BULLETIN NUMBER:
CB22-E-001A

FTR STEERING STOP BOLT ASSEMBLY REPLACEMENT – 21V-861
(Transport Canada 2021-679)

This bulletin supersedes previous campaign bulletin CB22-E-001. This bulletin is being revised to correct the torque specification for the adapter base. Please discard previous campaign bulletin CB22-E-001.

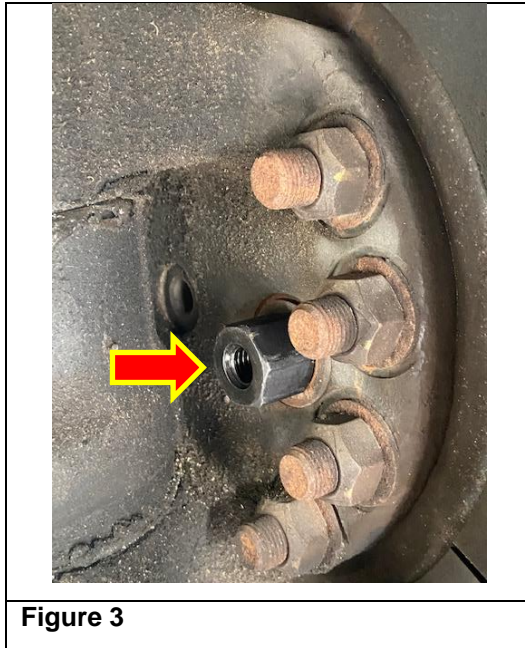
5. Install the **new** Adapter Base using a 1" socket as shown in Figure 3. Tighten the Adapter Base to the specified torque.

Tightening Torque: 131 N•m (97 lb ft).
